HISTORIC AND DESIGN REVIEW COMMISSION

HDRC CASE NO: 2024-365
COMMON NAME: Permit-ready ADU
APPLICANT: Krystin Ramirez, Neighborhoods and Housing Development Services
TYPE OF WORK: New Construction of an Accessory Dwelling Unit
APPLICATION RECEIVED: October 21, 2024
60-DAY REVIEW: December 20, 2024
CASE MANAGER: Cory Edwards

The City of San Antonio is requesting approval of permit-ready ADU plans which would be eligible for construction on properties that are designated historic landmarks or located within a local historic district. If approved, the design will be included in a library of permit-ready plans that residents can use. The proposed plans for the Maricela prototype have been modified to meet Historic Design Guidelines.

Image of constructed the Marisela ADU that doesn't include minor modifications made for Historic District applicability.

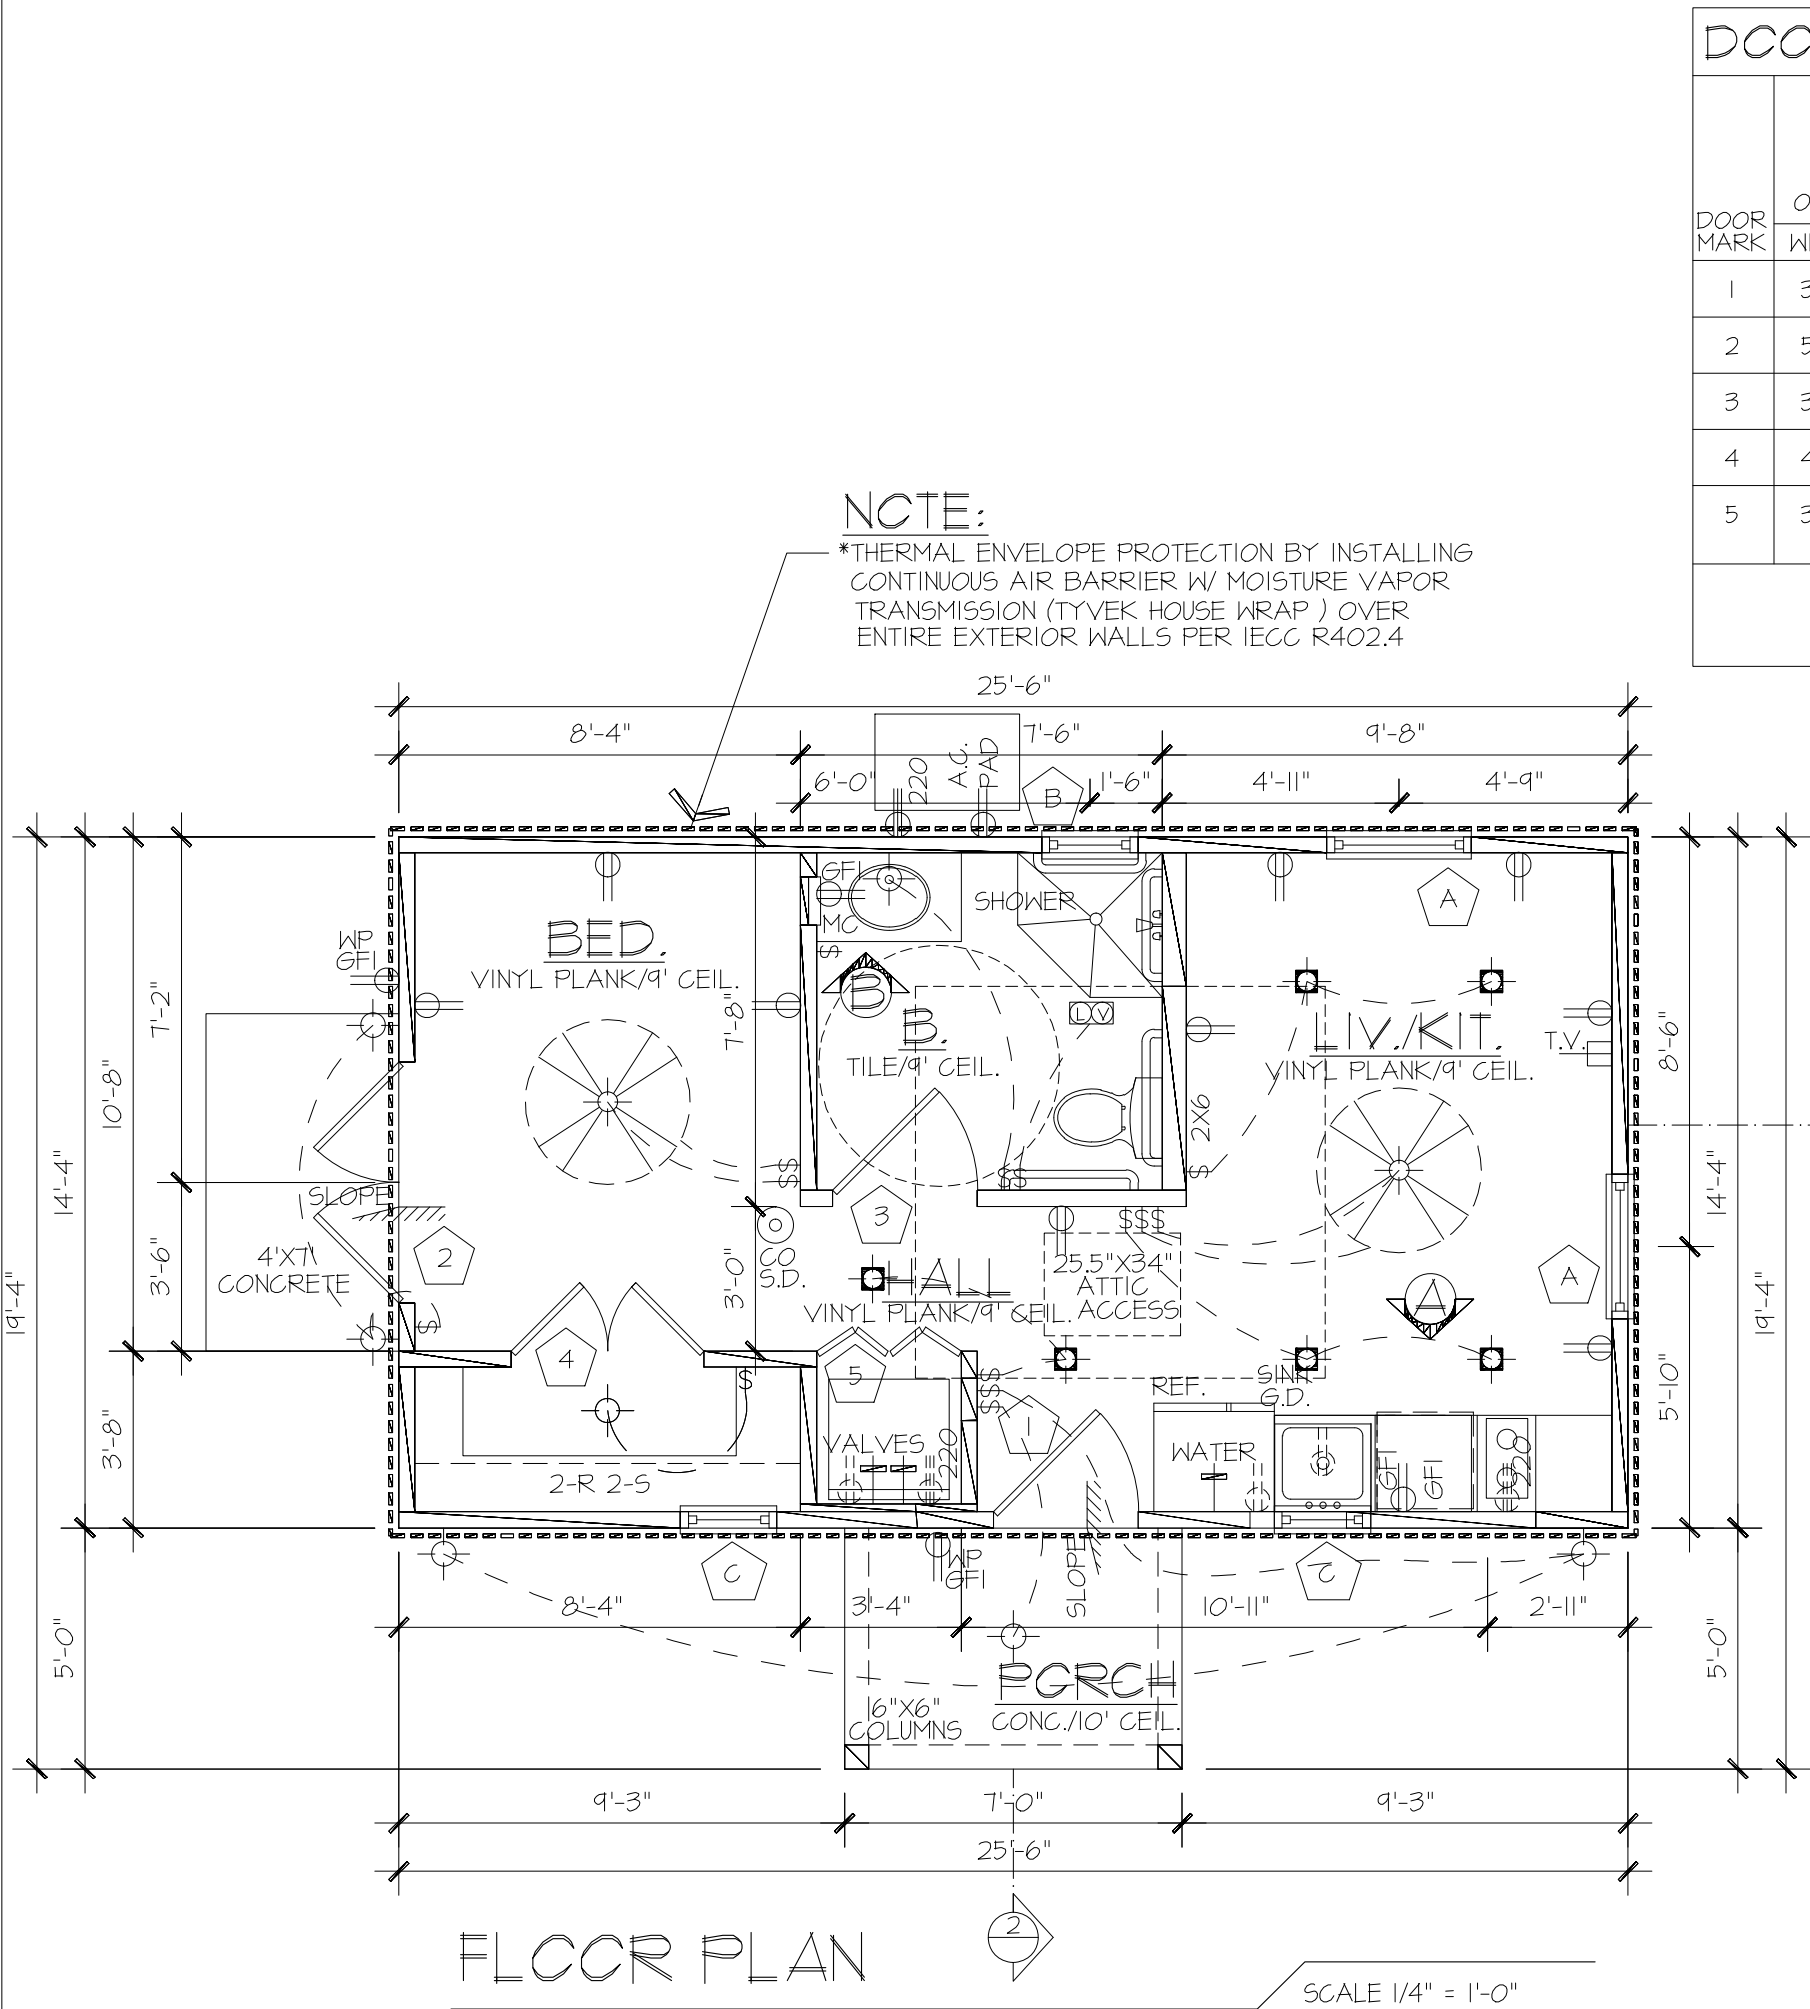
(These stipulations are demonstrated in the drawings, but not seen in the photos submitted. Paint colors and other details will be selected by individual property owners.)

SHEET NO.
A-1

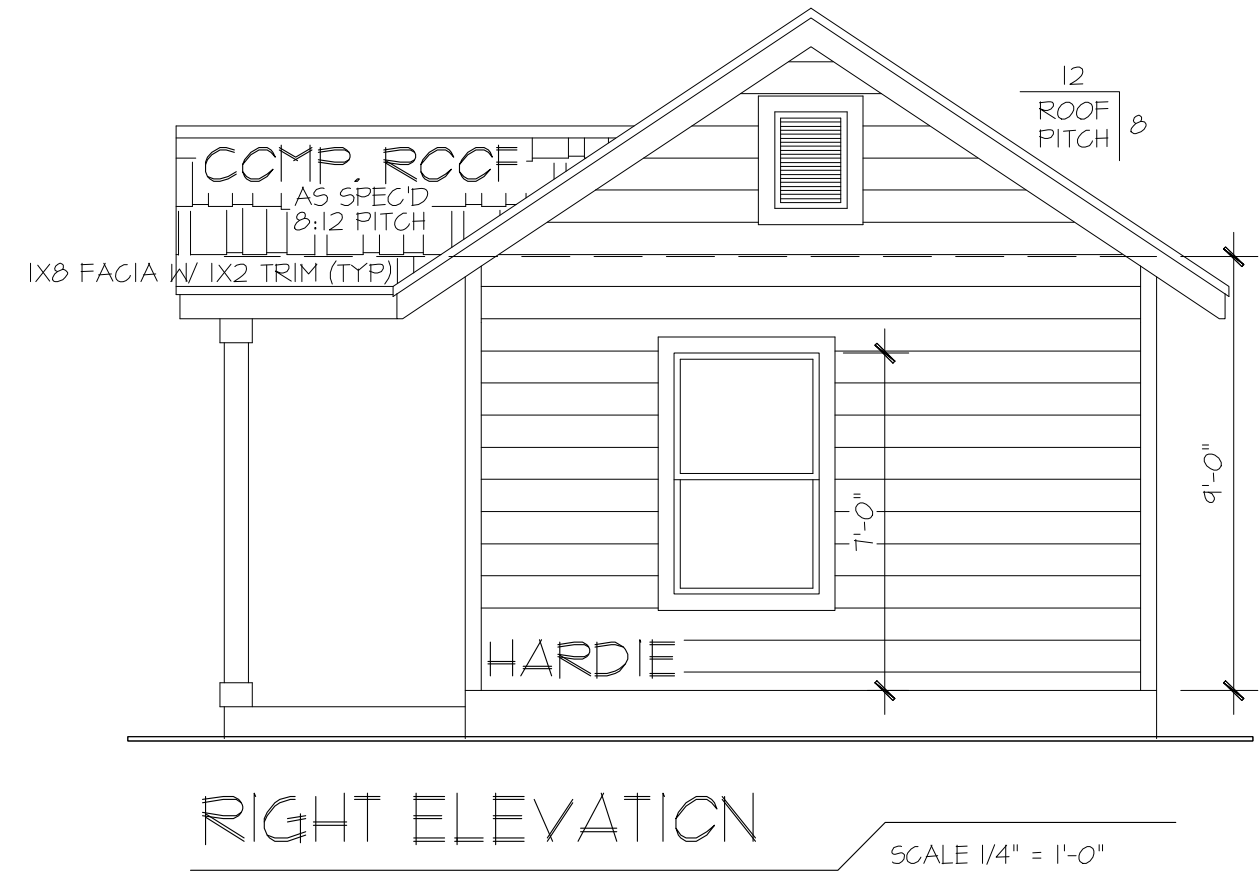
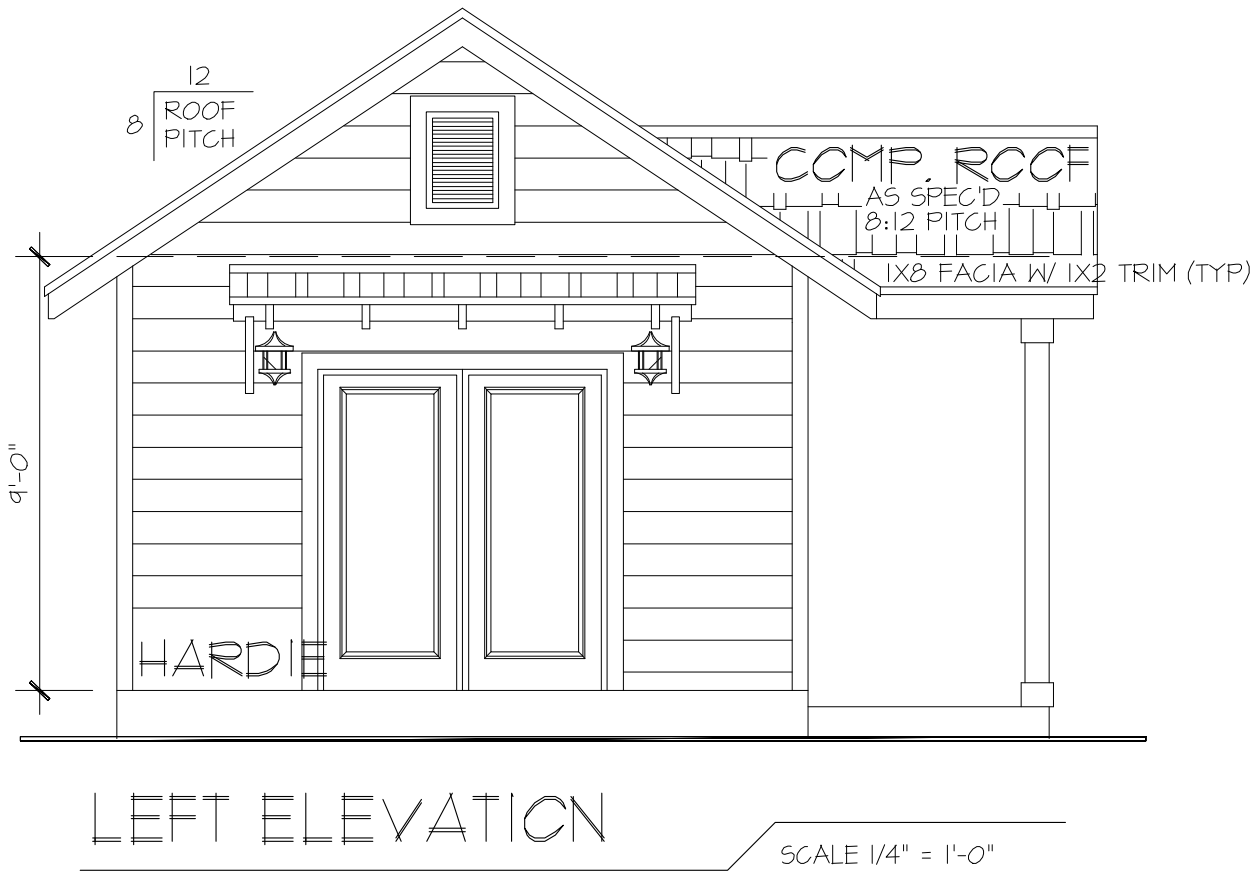
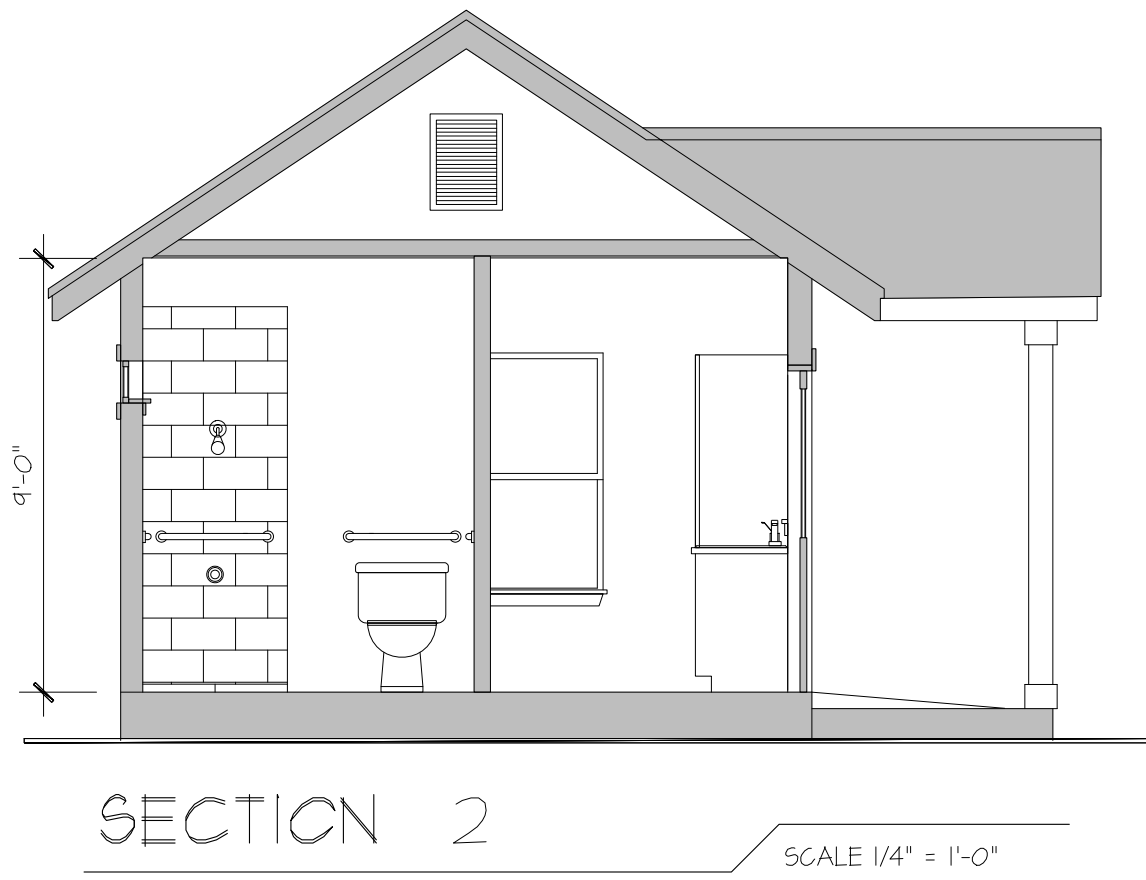
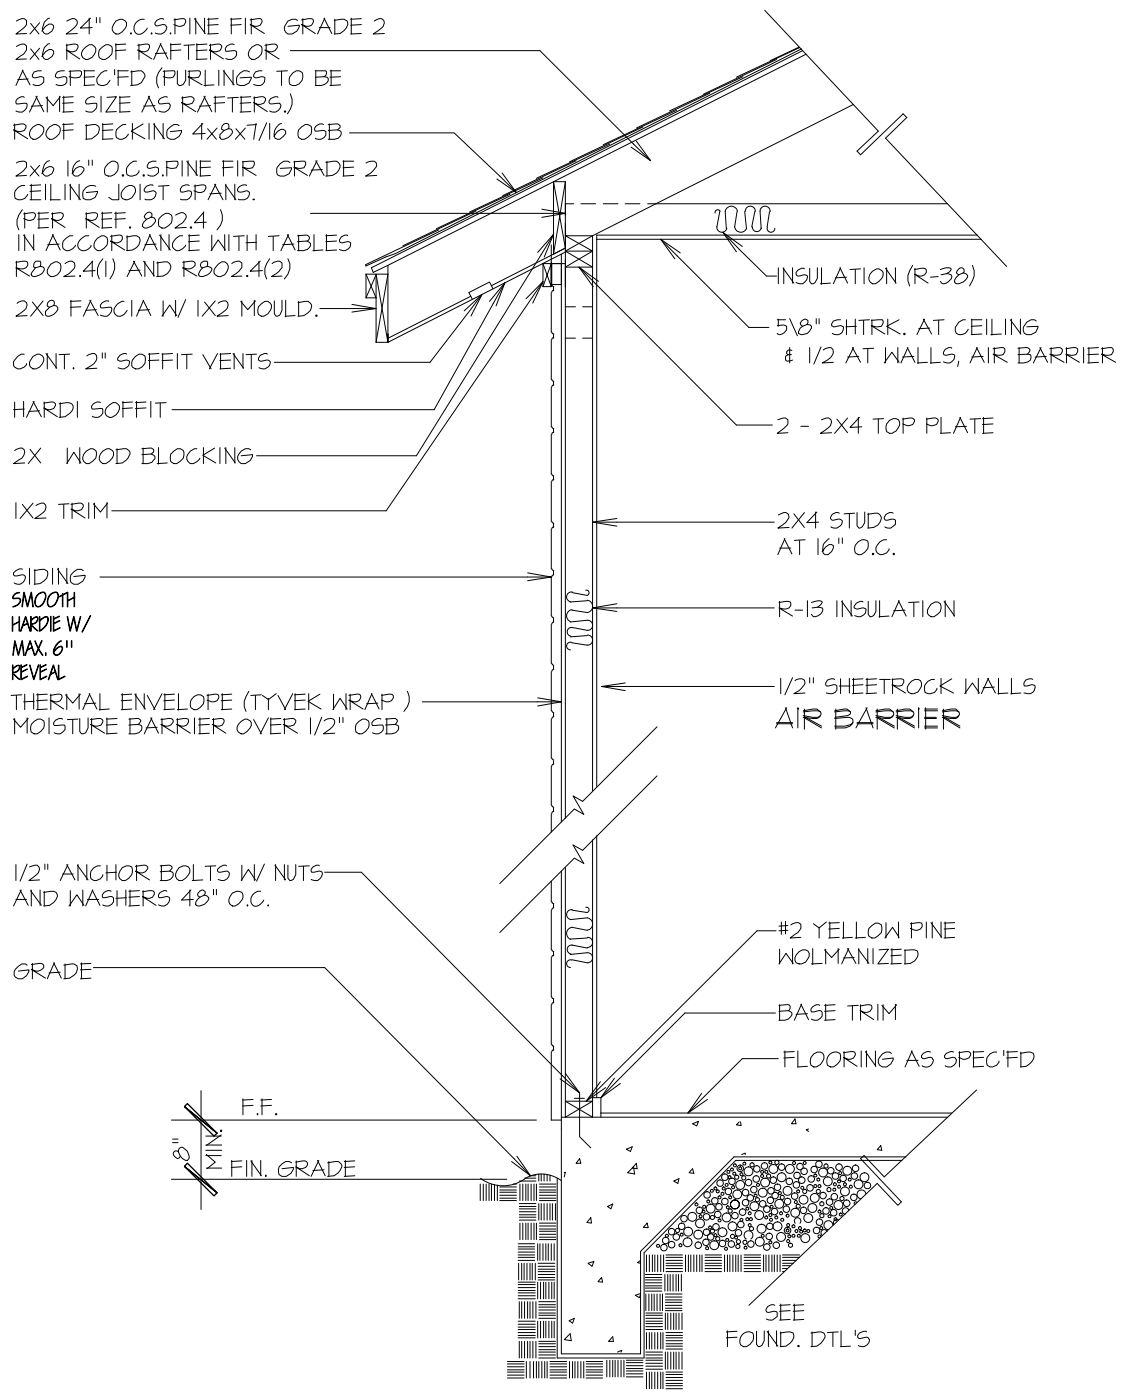
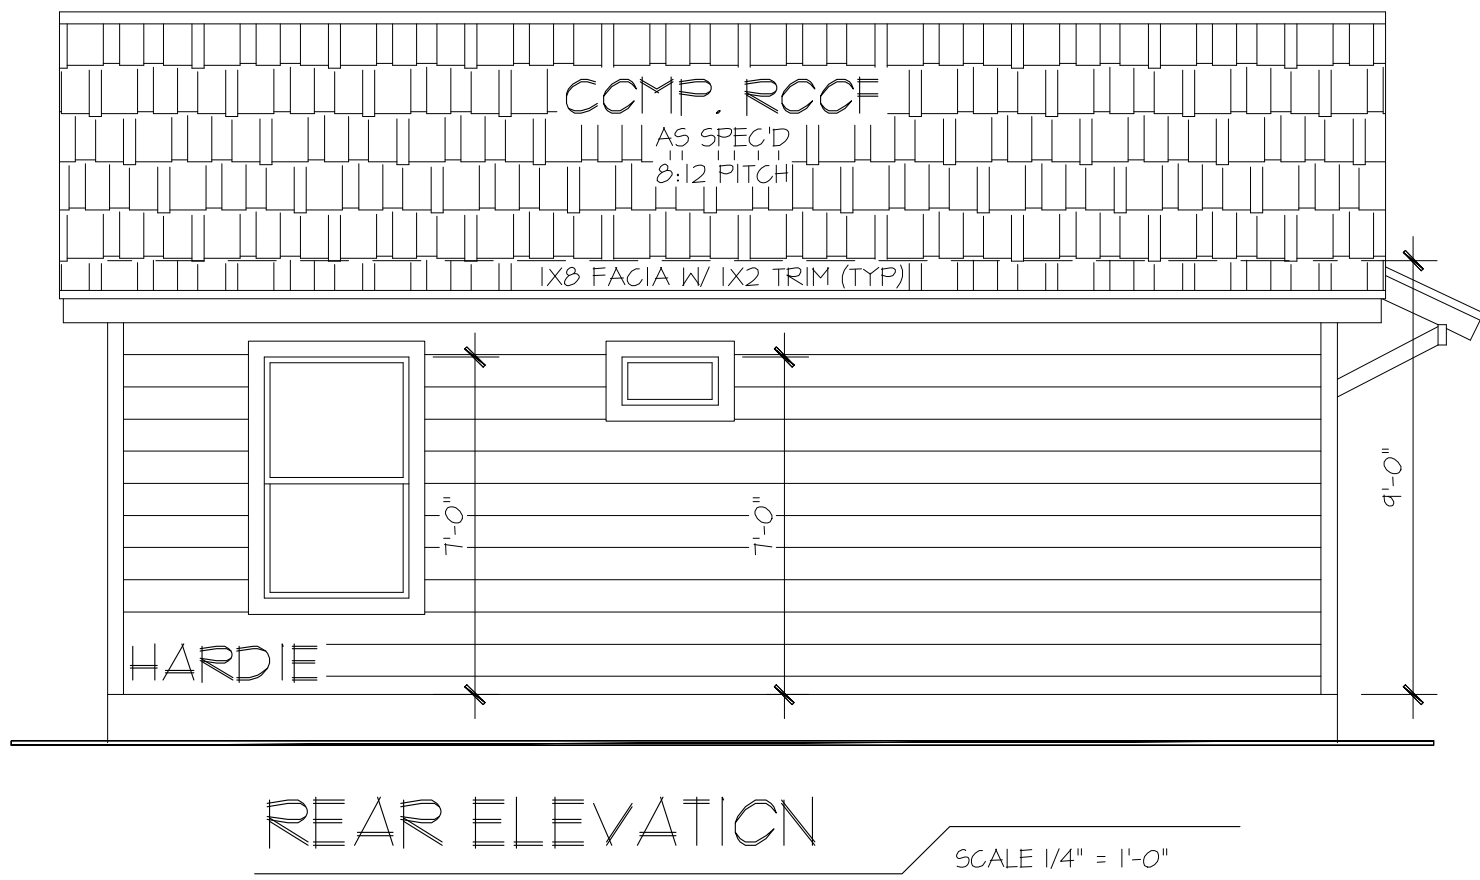
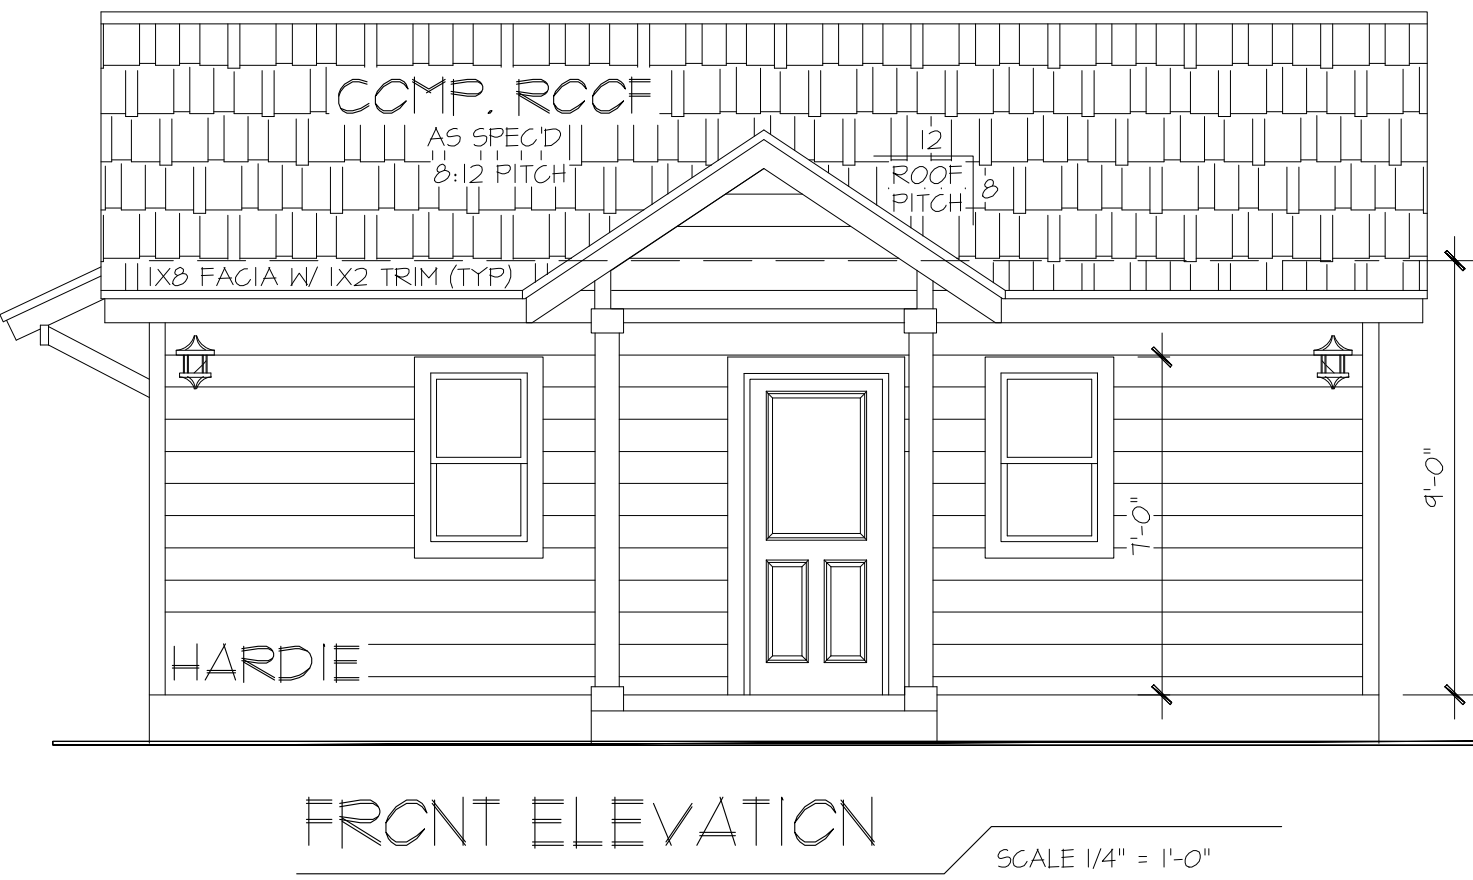
- e. MATERIALS & SPECIFICATIONS – Based on feedback from OHP staff, the Maricela design has been modified to incorporate the following stipulations:
 - i. That a hardie product with a smooth surface (no faux wood grain) be installed with a maximum 6” reveal.

- ii. That a sloped (or angled) soffit detail, as opposed to a boxed soffit, be implemented at the gable ends (see below).
 - iii. That façade with the covered entry feature two sash windows on either side of the porch. They should be equal in size and no smaller than 24” wide by 36” tall. Windows would ideally be inset a minimum of 2” from the face of the surrounding trim. Faux-divided lights are not allowed.

12. PREWIRE FOR SECURITY SYSTEM RE: OWNER
 13. LOOP WATER HEATER.
 14. ALL HARDIE SIDING MUST BE SMOOTH SURFACE (NO FAUX WOOD GRAIN) INSTALLED WITH A MAX. 6" REVEAL
